WSN3 - Replacing Service Cover on High-Voltage Battery E-box (Workshop Campaign)

Revision	Date	Change
0	12/15/2025	<ul style="list-style-type: none"> ▪ First Publication
1	05/19/2026	<ul style="list-style-type: none"> ▪ Update to Required Tools ▪ Update to Work Procedure ▪ Update to Scope 1

Model Line: **Macan (XAB)**

Installation position of service cover on E-box

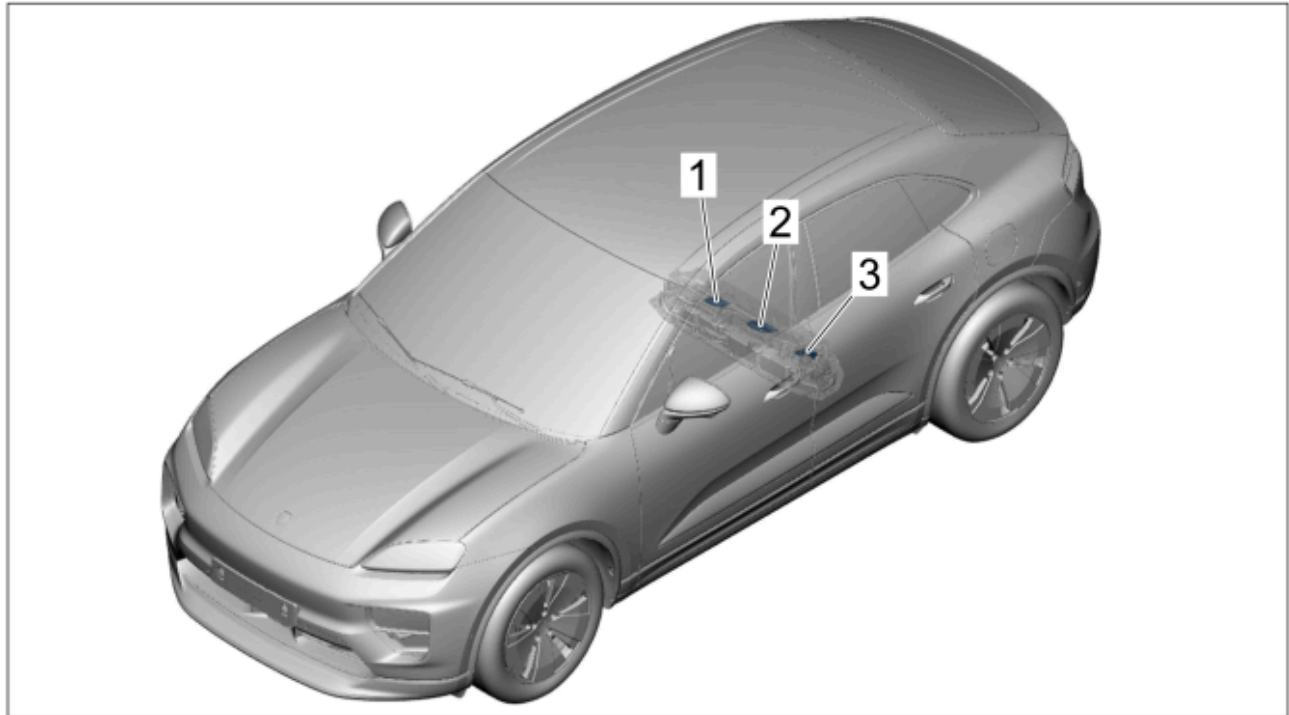
- 1 – Service cover for E-box on right (**replace**)
- 2 – Service cover for E-box in center (**replace**)
- 3 – Service cover for E-box on left (**replace**)

Service cover, right

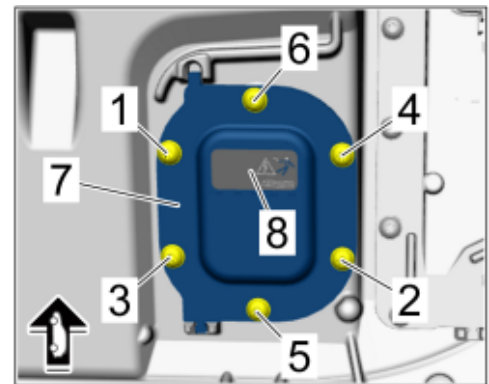
2 Replace service cover on the right ⇒ *Service cover, right -7-*.

2.1 Unscrew screws ⇒ *Service cover, right -1 to 6-* and remove **existing** service cover on the right ⇒ *Service cover, right -7-*.

2.3 Affix **new** information sign ⇒ *Service cover, right -8-* to **new** service cover on the right ⇒ *Service cover, right -7-*.

2.5 Screw in **new** screws and tighten **in sequence** ⇒ *Service cover, right -1 to 6-* with **Initial tightening 2 Nm (1.5 ftlb.)**.

2.6 Tighten **new** screws **in sequence** ⇒ *Service cover, right -1 to 6-* with **Final tightening 4.5 Nm (3.3 ftlb.)**.

Center service cover

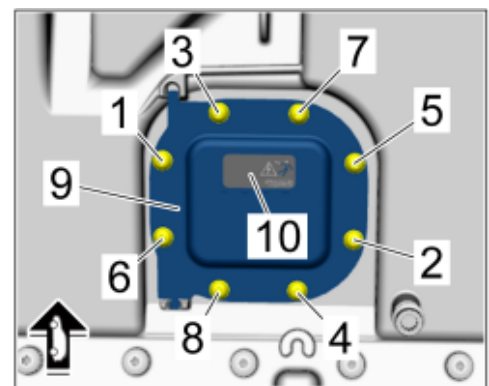
3 Replace center service cover ⇒ *Center service cover -9-*.

3.1 Unscrew the screws ⇒ *Center service cover -1 to 8-* and remove **existing** center service cover ⇒ *Center service cover -9-*.

3.3 Affix **new** information sign ⇒ *Center service cover -10-* to **new** center service cover ⇒ *Center service cover -9-*.

3.5 Screw in **new** screws and tighten **in sequence** ⇒ *Center service cover -1 to 8-* with **Initial tightening 2 Nm (1.5 ftlb.)**.

3.6 Tighten **new** screws **in sequence** ⇒ *Center service cover -1 to 8-* with **Final tightening 4.5 Nm (3.3 ftlb.)**.

Service cover on the left

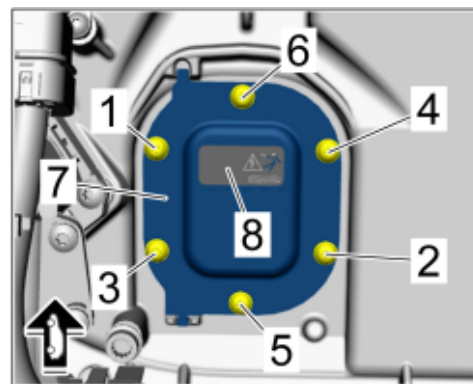
- 4 Replace ⇒ *Service cover on the left -7-* service cover on the left.
 - 4.1 Unscrew the ⇒ *Service cover on the left -1 to 6-* screws and remove **existing** left service cover ⇒ *Service cover on the left -7-*.

- 4.2 Remove adhesive residue.
 - 4.3 Affix **new** information sign ⇒ *Service cover on the left -8-* to **new** service cover on the left ⇒ *Service cover on the left -7-*.

- 4.4 Position **new** service cover on the left ⇒ *Service cover on the left -7-*.
 - 4.5 Screw in **new** screws and tighten **in sequence** ⇒ *Service cover on the left -1 to 6-* with **Initial tightening 2 Nm (1.5 ftlb.)**.

- 4.6 Tighten **new** screws **in sequence** ⇒ *Service cover on the left -1 to 6-* with **Final tightening 4.5 Nm (3.3 ftlb.)**.
- 5 Carry out the high-voltage battery leak test **in the installed condition**.
For procedure, see: ⇒ *Workshop Manual '930303 Measure high-voltage battery (leak test)'*
